C0960-006
May 20, 2020

**Re: Site Review Permit & Conditional Use Permit for Parking Applications
Proposed Multi-Family Development, 105 Bartlett Street, Portsmouth, NH**

The enclosed revised plans and supplemental materials have been provided to address comments received from the Technical Advisory Committee (TAC) at their meeting held on May 5, 2020. Also enclosed is a Site Review Comment Response that includes responses to City staff comments.

City of Portsmouth TAC, May 05, 2020:			
	TAC Comment	Applicant Response	Sheet
TAC Comments from 5/4 Correspondence:			
1	Plans list proposed building height 54 story and 50' for buildings B and C, this appears to be a typo as the building is proposed to be 5 stories using the overlay district zoning. Please correct.	The site data table has been revised to a 4 story and 50' for buildings B and C.	C-102
2	A detailed building height plan should be submitted showing the average grade plane and heights along the perimeter of the building.	An average grade plane exhibit has been added to the submission package.	Grade Plane Exhibit
3	An application for a lot line adjustment is also being submitted, please clarify on plan set if the lot dimens

UTILITIES PLAN

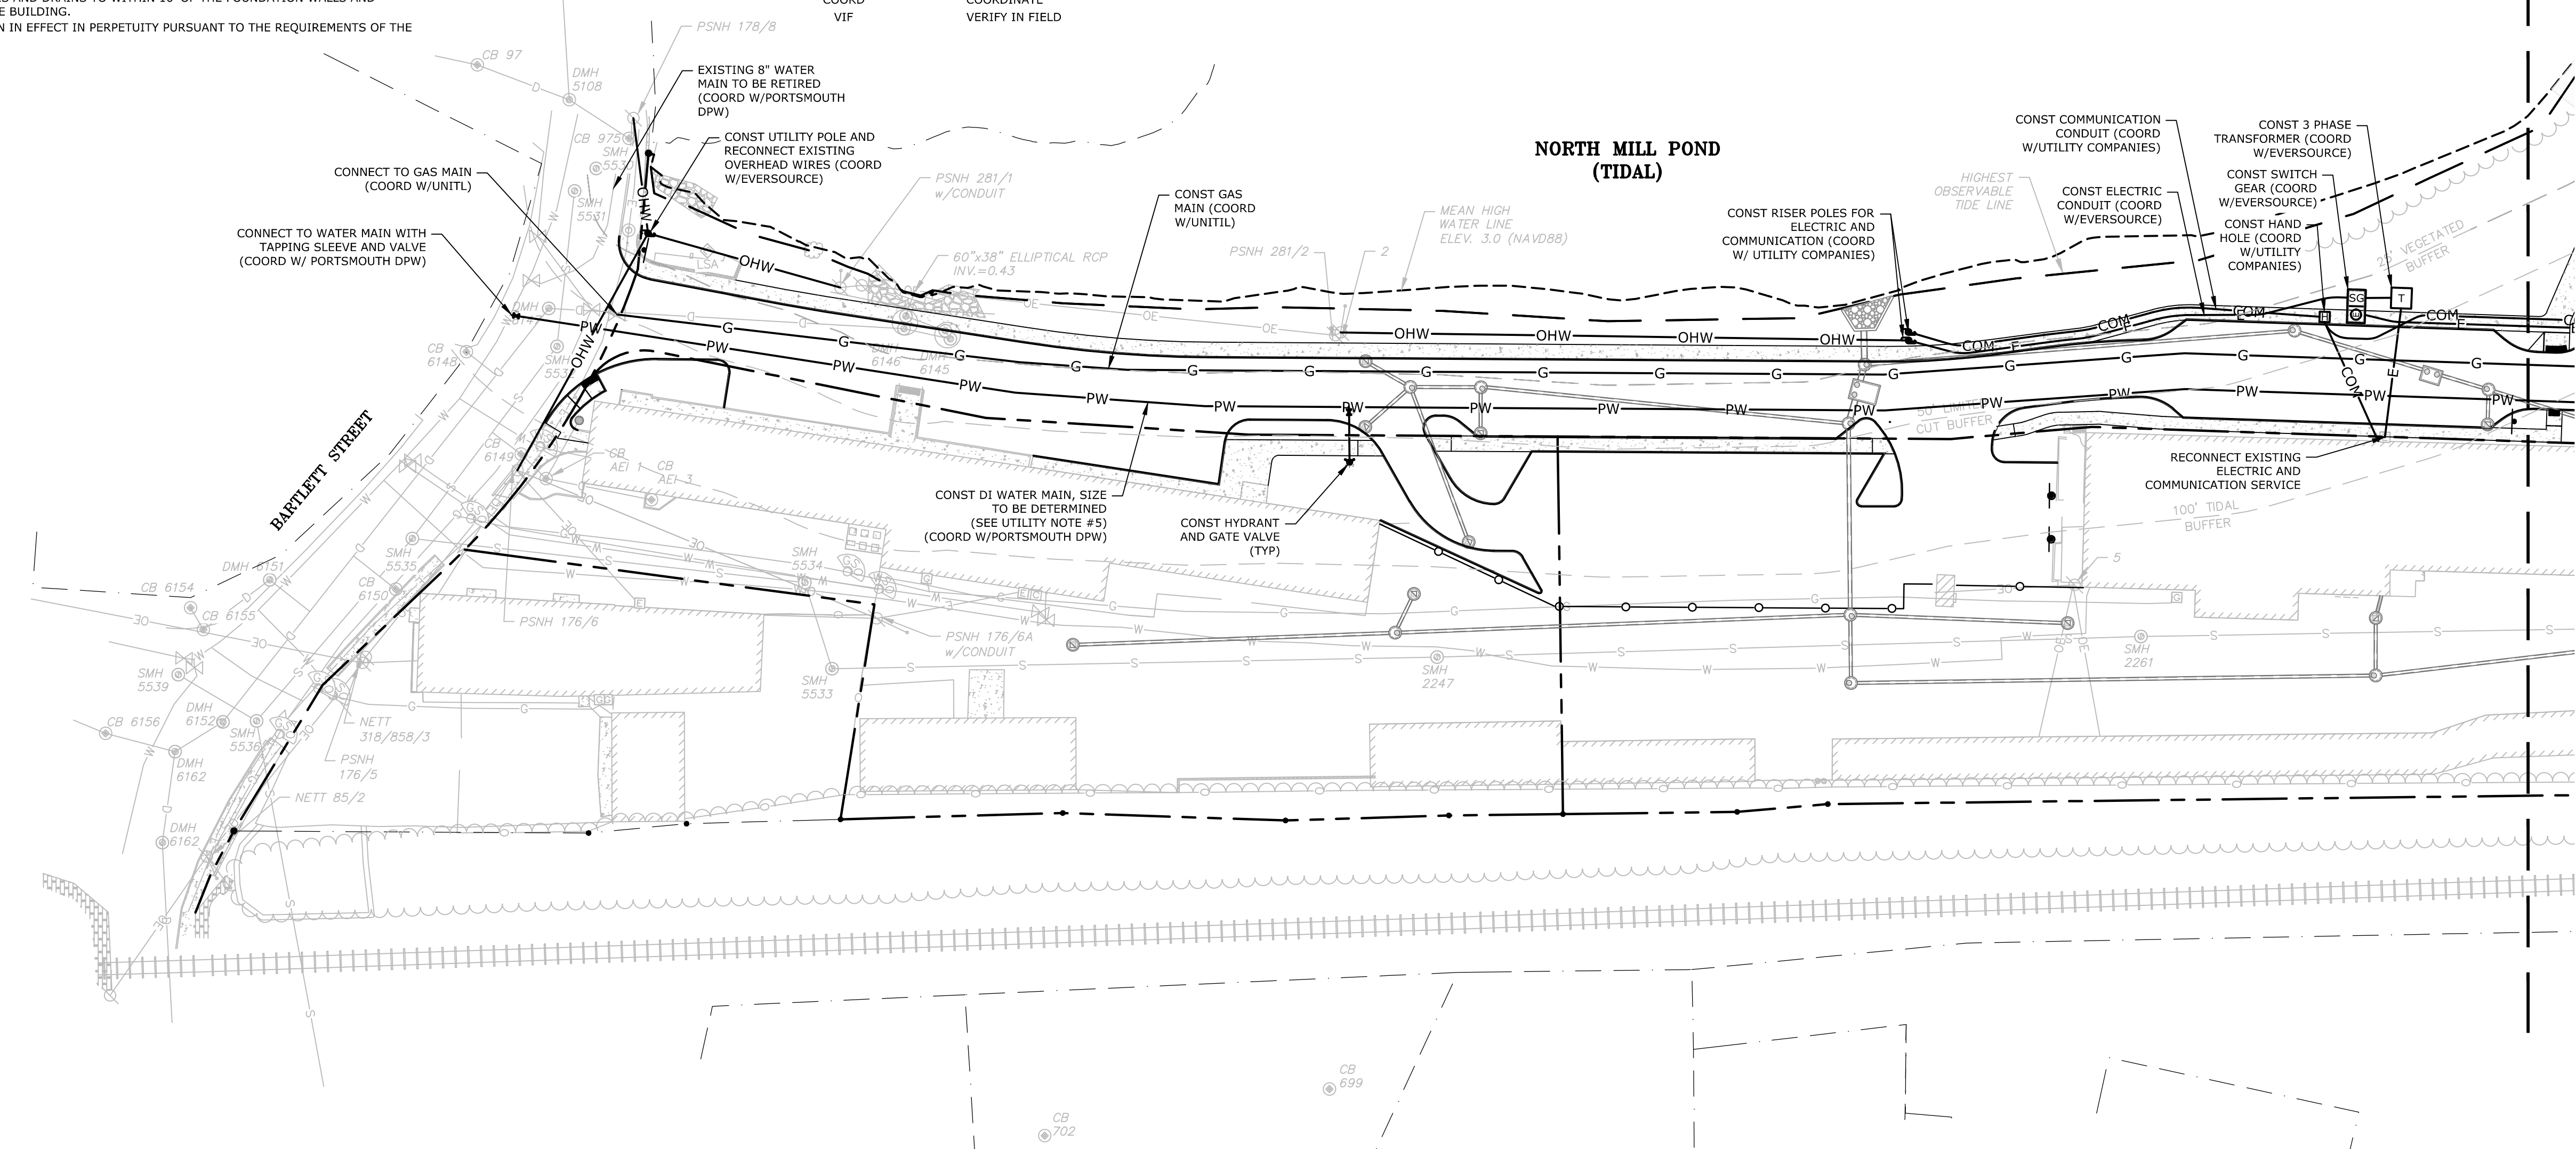
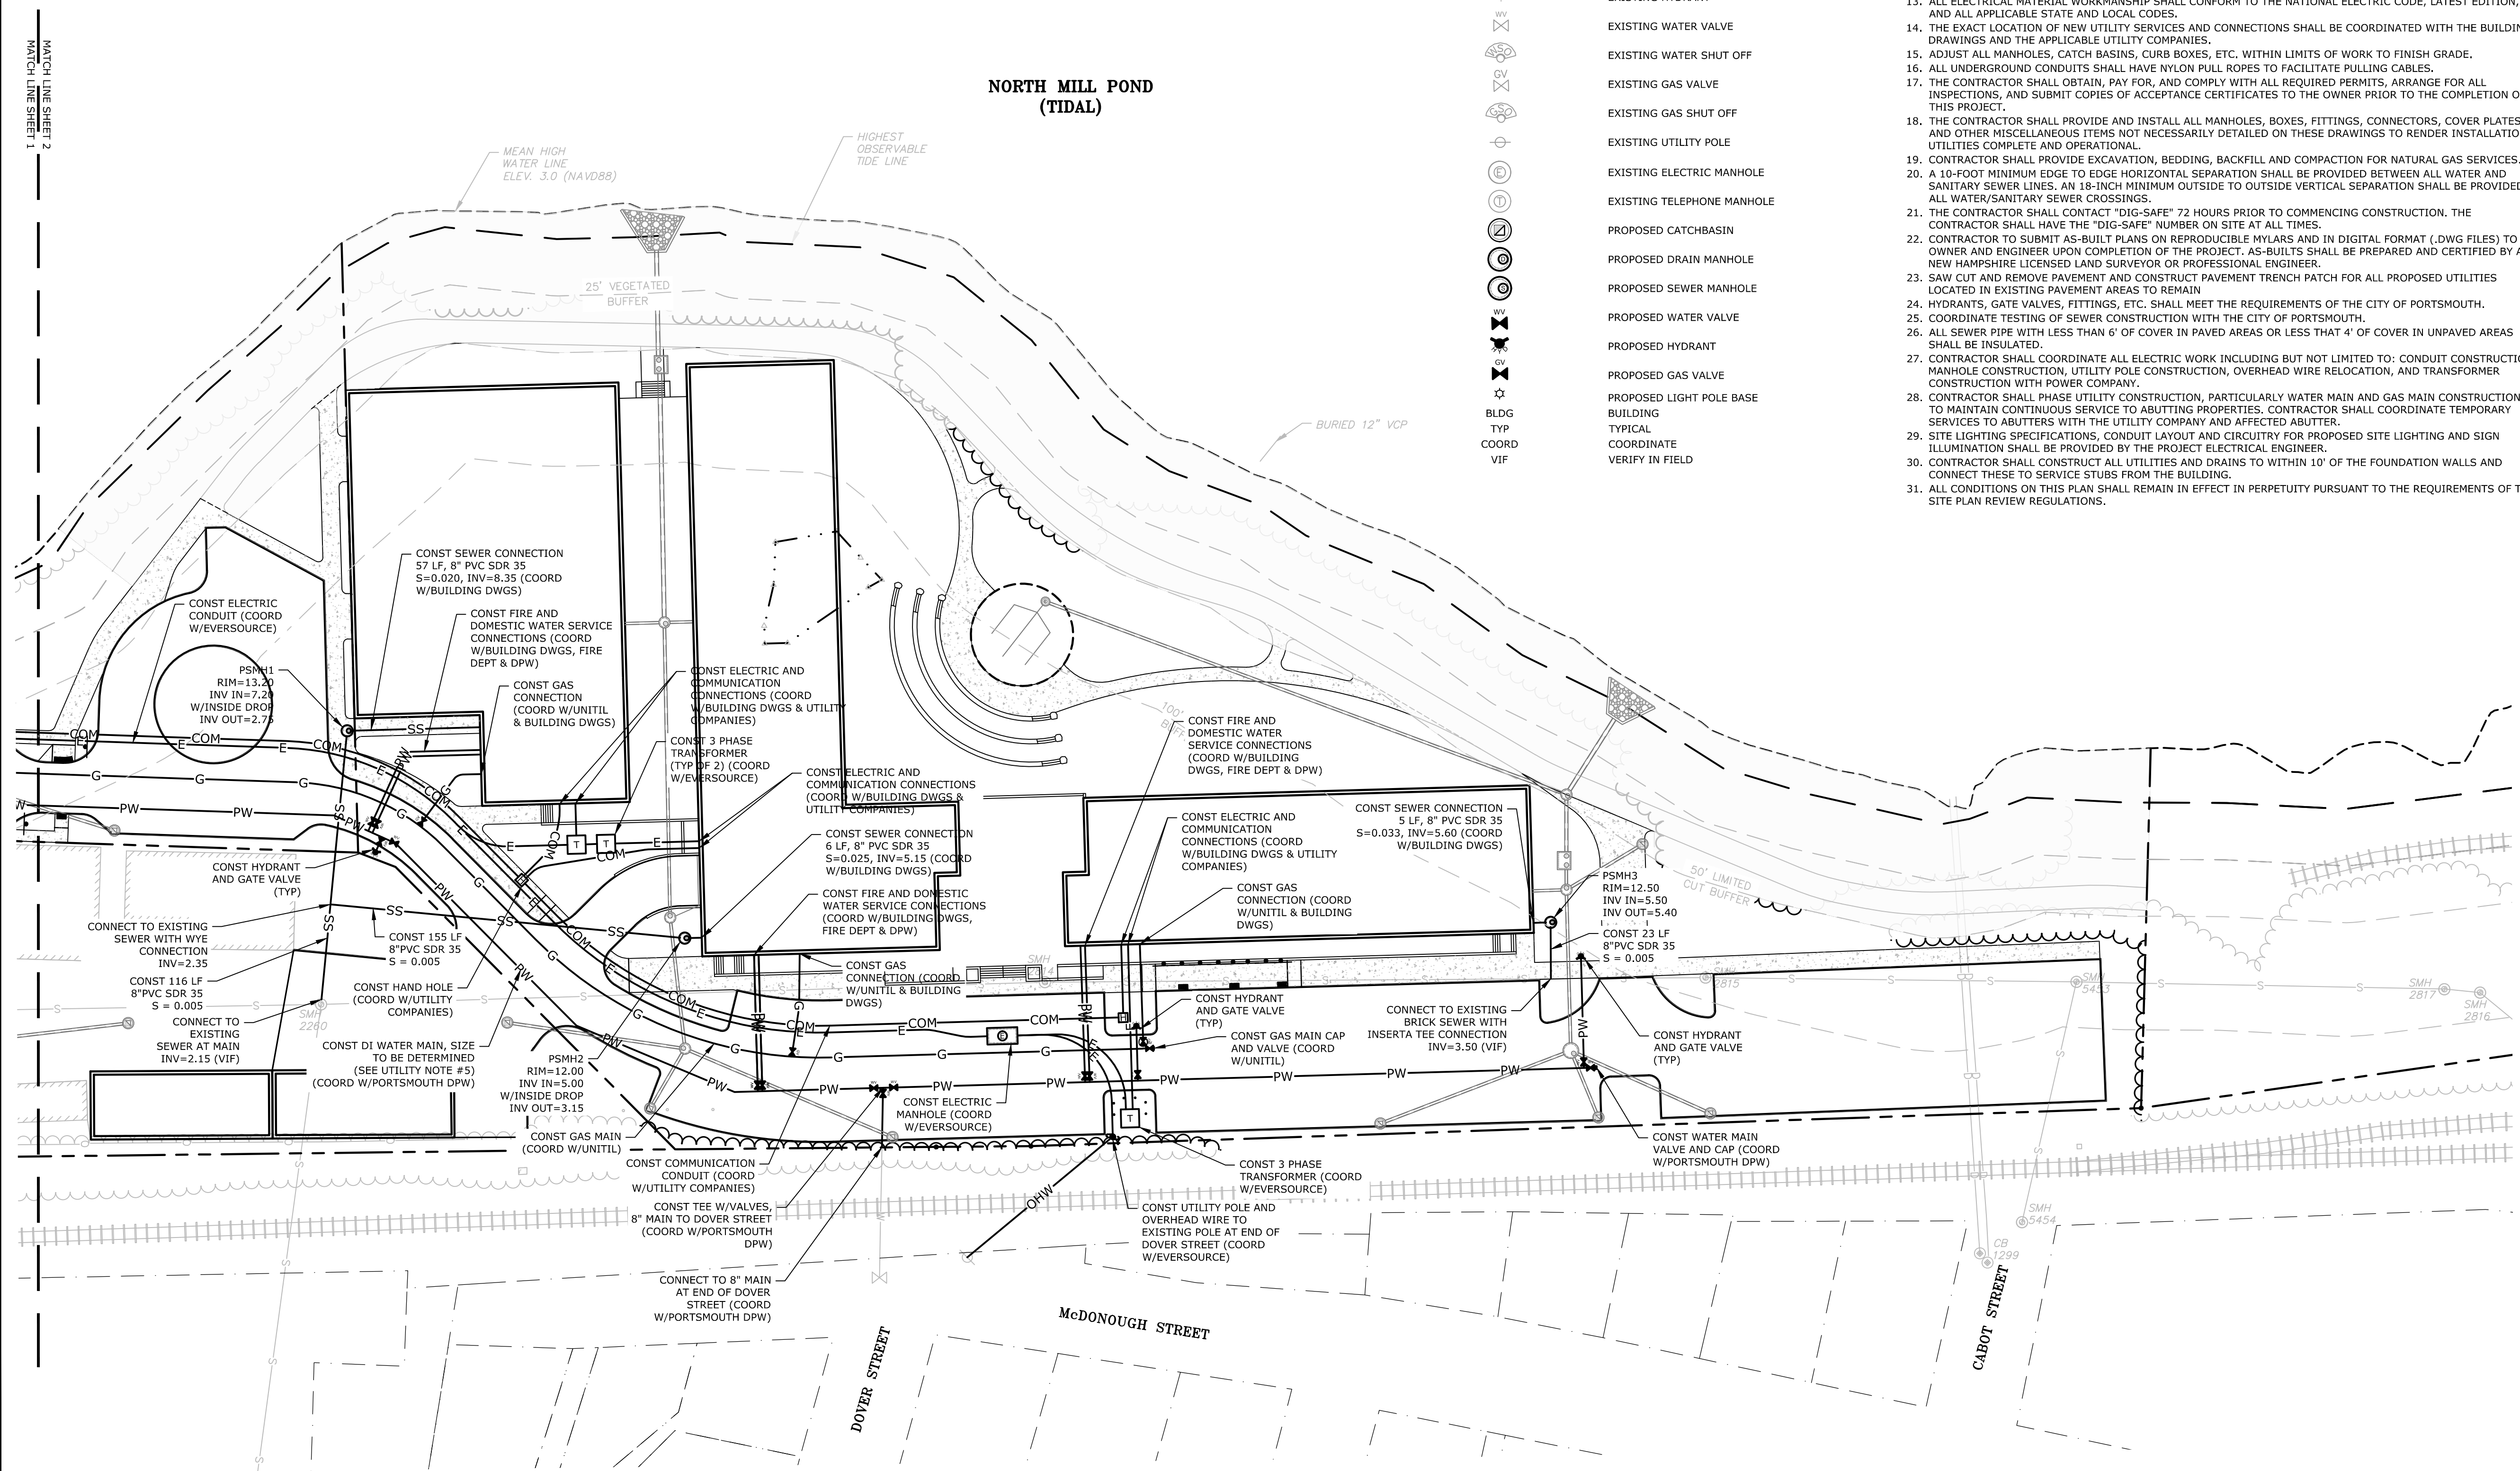
11	Consider an additional fire hydrant on the other side of Building A.	A fire hydrant has been added to the end of Building A.	C-102.2 & C-104.2
12	What are the addresses of the buildings going to be?	The applicant will work with the GIS and Fire Departments to determine the appropriate addresses for proposed buildings.	N/A
13	The roof drains entering the buildings may want to be PVC so they can be sealed up properly when penetrating the building.	The roof drains have been revised to be PVC where entering the buildings.	C-103.2
14	Move the hydrant proposed by the kitchen store off the island to behind the sidewalk 30' closer to Bartlett St.	The hydrant proposed by the kitchen store has been moved off the island to behind the sidewalk 30' closer to Bartlett St.	C-102.1 & C-104.1
15	The proposed outfall is too close to the power and communication drops from the existing poles.	The proposed power and communication drops and proposed outfall have been moved further apart.	C-104.1

16	The water pipe coming from Dover St needs to be replaced.	A label has been added to the Utility Plan indicating new water pipe shall be connected to the end of Dover Street.	C-104.2
17	What is the size, material type and manhole data for the sewer line leaving great rhythm that is to be reused?	Utility Plan show a new sewer main for Building B & C service connections.	C-104.2
18	Do not place the structure within 15' of the center of the brick box.	Utility Plan has been revised to show all proposed structures 15ft from center of City sewer.	C-104.2

19	The 8" water main on Bartlett St should be retired as part of this project from the common site driveway to Woodbury Ave.	Utility Plan has been revised to indicate this line will be abandoned.	C-104.1
20	Independent third party review and inspection of all utilities and stormwater will be required.	Acknowledged.	N/A
21	One-way flow with angled parking should remain in same direction as today.	The angled parking in the lot in front of Ricci Lumber has been reversed to match the existing condition.	C-102.1
22	Parking around cul-de-sac will be challenging for drivers to parallel park into. Could stick out into drive aisle and impede traffic and emergency vehicles. Vehicles are rectangular, not curved, like trying to fit a square peg in a round hole.	Parking spaces around the cul-de-sac have been revised to angled spaces to avoid potential conflicts in the cul-de-sac.	C-102.2
23	Long dead-end parking aisle will result in vehicles backing up if no open spaces at end. Snow storage will eliminate any chance to turn around in winter.	Snow storage location has been revised to maintain striped aisle at dead end for turn around.	C-102.2

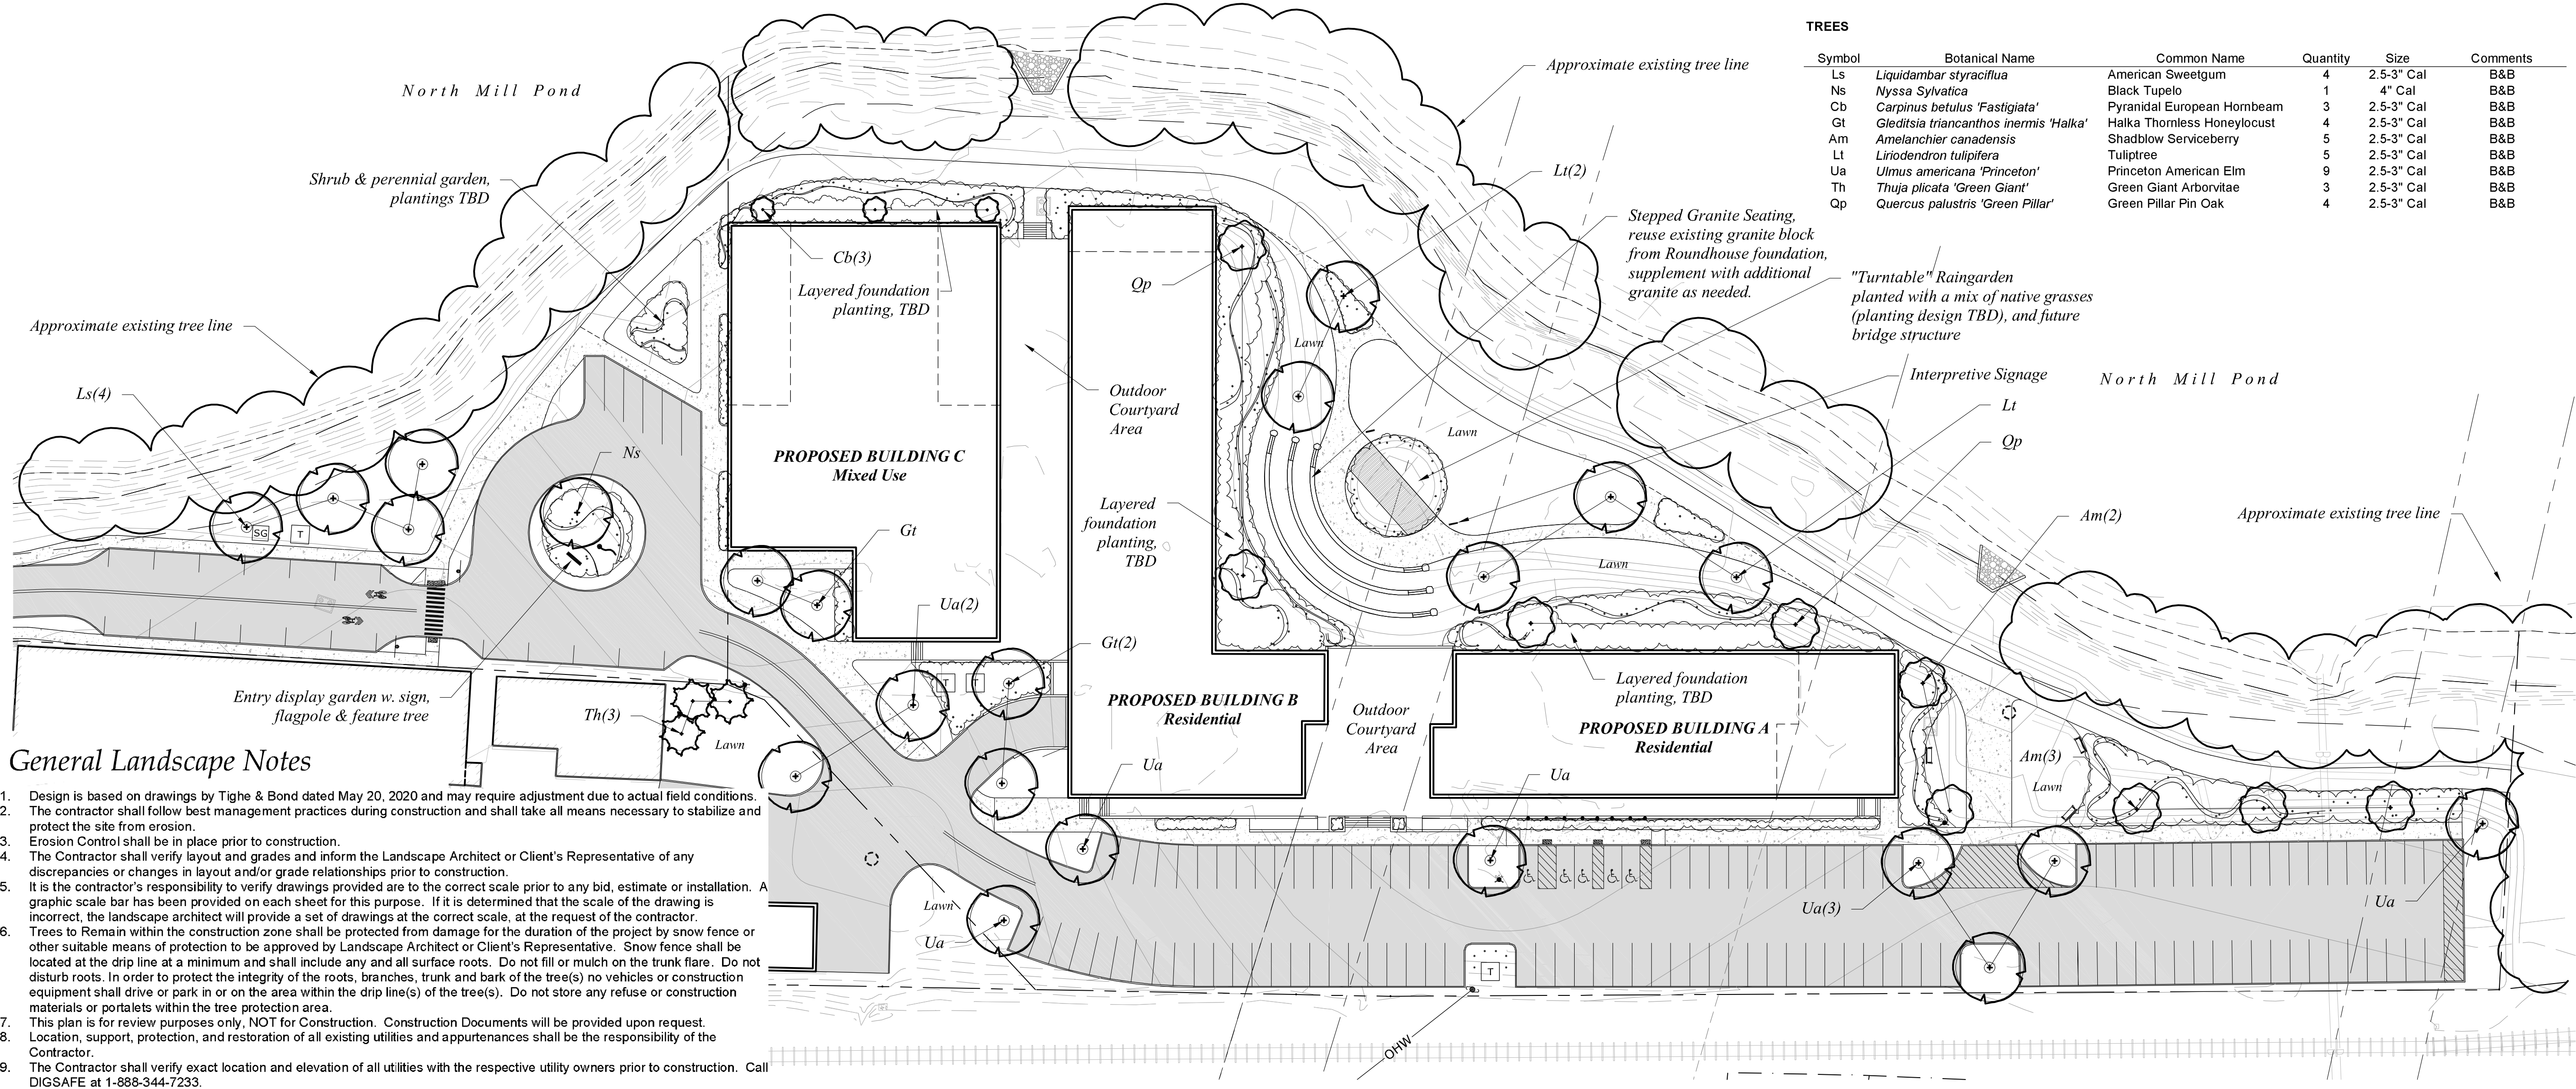
4	The building block lengths are accurately measured along the public greenway. For clarity, please clearly label the building lengths along that frontage to verify compliance with zoning requirements.	The building block length along the frontage have been labelled to verify compliance with zoning requirements.	C-102 & C-102.2
5	Has the applicant considered porous pavement for the parking lot area?	Due to the high water table at the site, porous pavement was not considered. Stormwater in the parking area will be treated via stormwater treatment units that are NHDES approved stormwater technologies.	C-103.1 & 103.2
6	The landscape plan is understandably conceptual in the future trail easement area. More details are necessary for the areas outside of the proposed trail easement area.	Landscape Plan with plantings, plant list, notes and details has included with the revised plan set.	L-1
7	There is reference to the raingarden planting details - have they been provided?	Rain garden cross section details are included in the Detail Sheets. Rain garden plantings have been identified as Native Grasses on the Landscape Plan.	C-505, L-1
